Robinson Helicopter Company

SERVICE LETTER #13

Subject: Loose horizontal firewall to steel tube frame attach bolts

Rotorcraft Affected: R22 Serial No. 0002 thru 0150, 0152-0182, 0184-0188
0190-0195, 0198

Fig #1

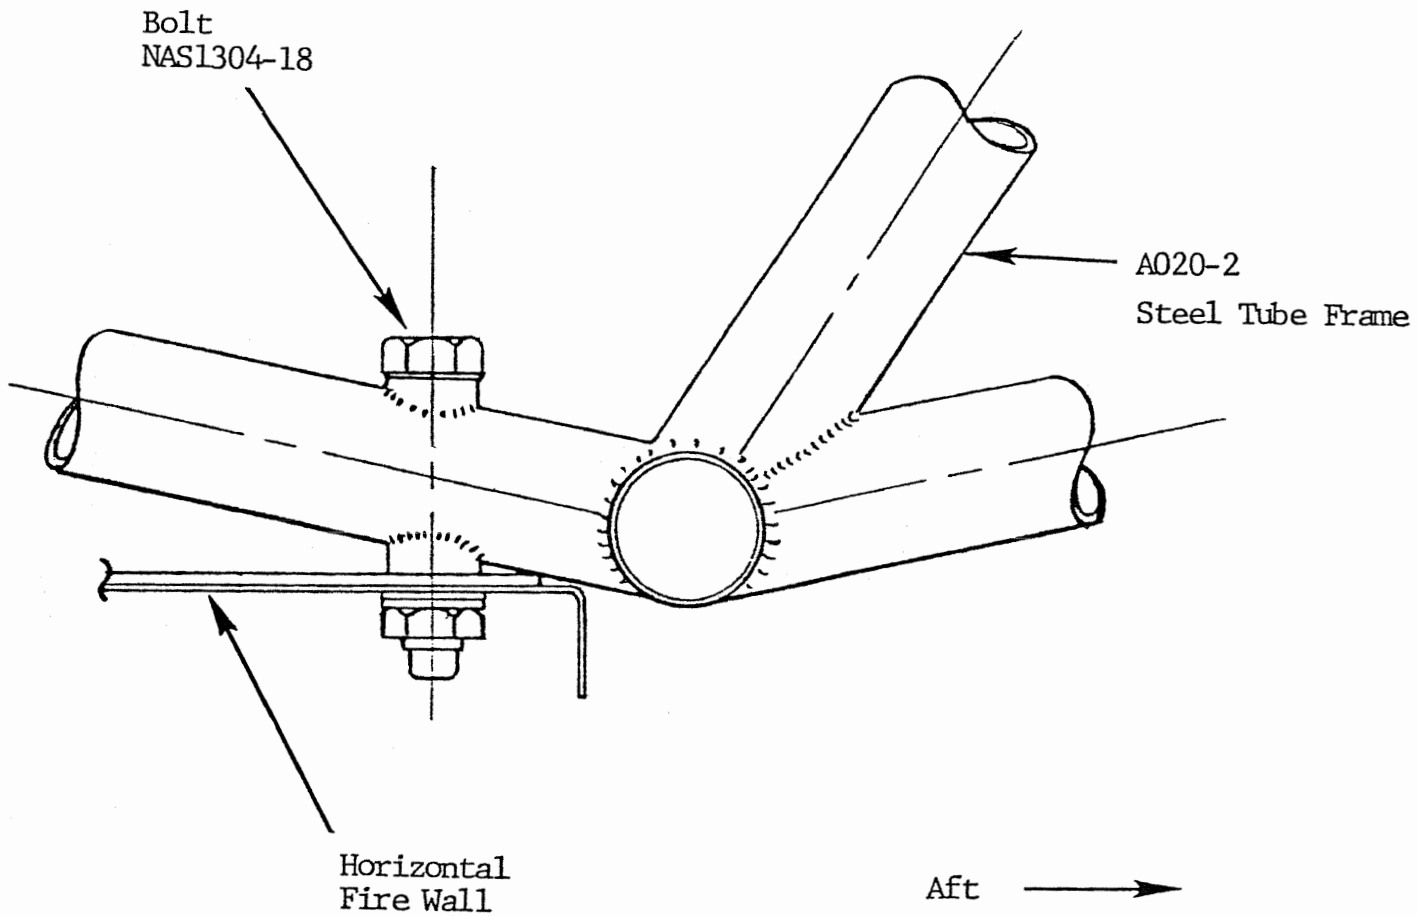
Background: After inspecting a number of helicopters, several were found to have loose NAS1304-18 attach bolts fastening the upper steel tube frame (lower horizontal member) to the aft horizontal firewall. (See fig. #1) To prevent improper loading at these areas, the NAS1304-18 bolts must be checked for proper torque and retorqued as necessary to provide proper clamping of these joints.

1. Using a suitable torque wrench, torque the bolts to 100 in/lbs plus nut drag.

Due to inaccessability of nut, it is permissible to hold the nut and torque the bolt.

2. Torque stripe the nut.

Note:
Torque nuts to 100 inch/pounds
plus nut drag
